Additions and Corrections

This report includes additional information, and technical errors found between June 15, 2005, and April 7, 2009, in the inch-pound (I-P) editions of the 2006, 2007, and 2008 *ASHRAE Handbook* volumes. Occasional typographical errors and nonstandard symbol labels will be corrected in future volumes. The most current list of Handbook additions and corrections is on the ASHRAE Web site (www.ashrae.org).

Fig. 37 Building Vibration Criteria for Vibration Measured on Building Structure

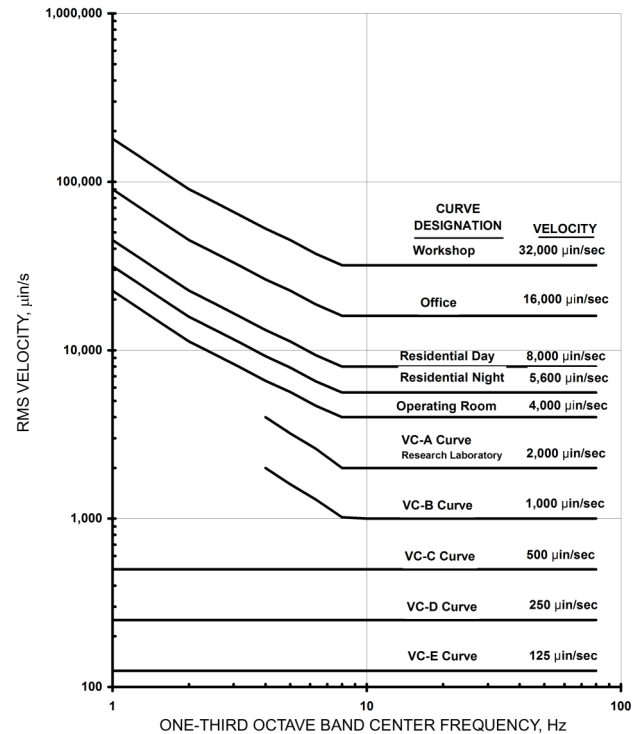
p. 47.39, Fig. 37. The corrected figure is as shown above.

Fig. 1 Typical Water Circuit Arrangements
(2008 HVAC Systems and Equipment, Chapter 22, p. 1)

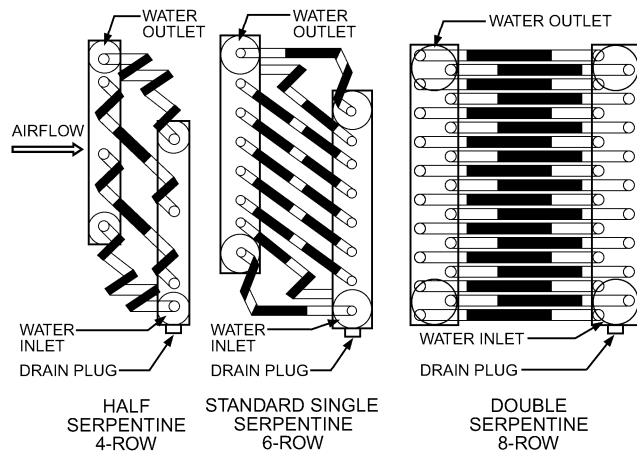
p. 22.1, Fig. 1. Replace the figure with the one shown above.

Fig. 7 Typical Rotary Dehumidification Wheel
(2008 HVAC Systems and Equipment, Chapter 23, p. 4)

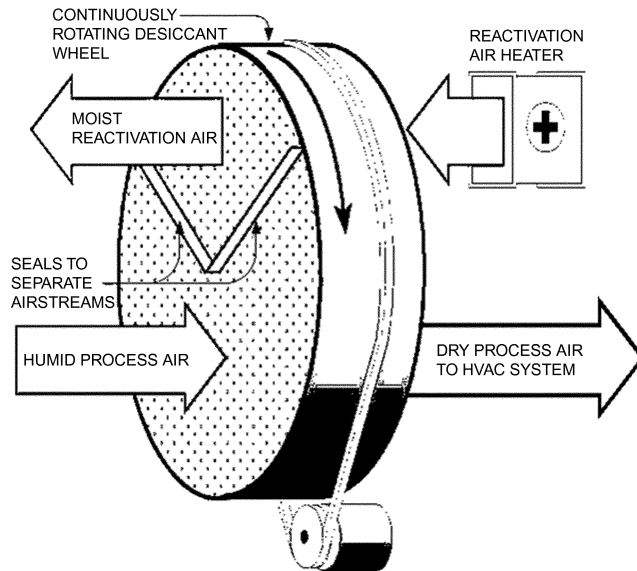
p. 23.4, Fig. 7. Replace the figure with the one shown above.
